GUIDANCE FOR THE SURVEY AND CONSTRUCTION OF STEEL SHIPS

Load Lines

2007 AMENDMENT NO.1

Notice No.51 27th September 2007

Fig. V2.2.1-1.(1)

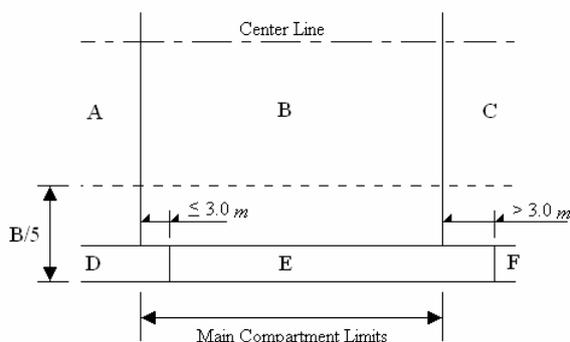
- 4 When there are steps or recesses in a transverse bulkhead, assumed damages specified in regulation 27(12) of *ILLC* are to be determined as per **Fig. V2.2.1-1(1)** to **(4)**.

Compartments to be considered damaged simultaneously:

$$\begin{aligned} & \underline{A + D} \\ & \underline{B + E} \\ & \underline{C + E + F} \end{aligned}$$

Fig. V2.2.1-1.(2)

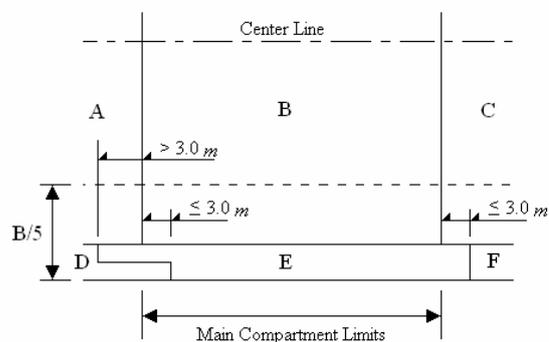
Compartments to be considered damaged simultaneously:

$$\begin{aligned} & \underline{A + D + E} \\ & \underline{B + E} \\ & \underline{C + F} \end{aligned}$$

Fig. V2.2.1-1.(3)

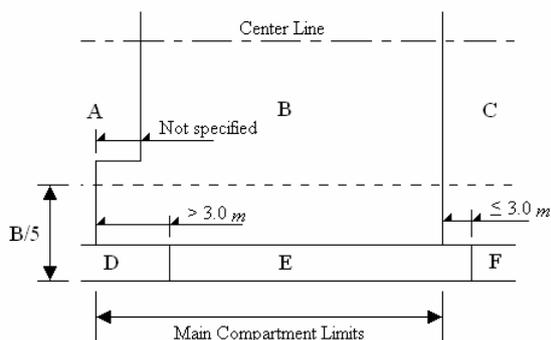
Compartments to be considered damaged simultaneously:

$$\begin{aligned} & \underline{A + D} \\ & \underline{B + D + E} \\ & \underline{C + F} \end{aligned}$$

Fig. V2.2.1-1.(4)

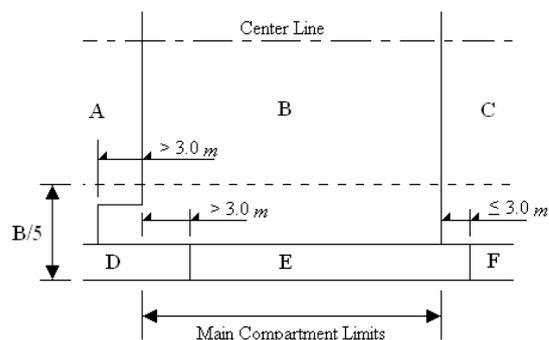
Compartments to be considered damaged simultaneously:

$$\begin{aligned} & \underline{A + B + D} \\ & \underline{B + D + E} \\ & \underline{C + F} \end{aligned}$$
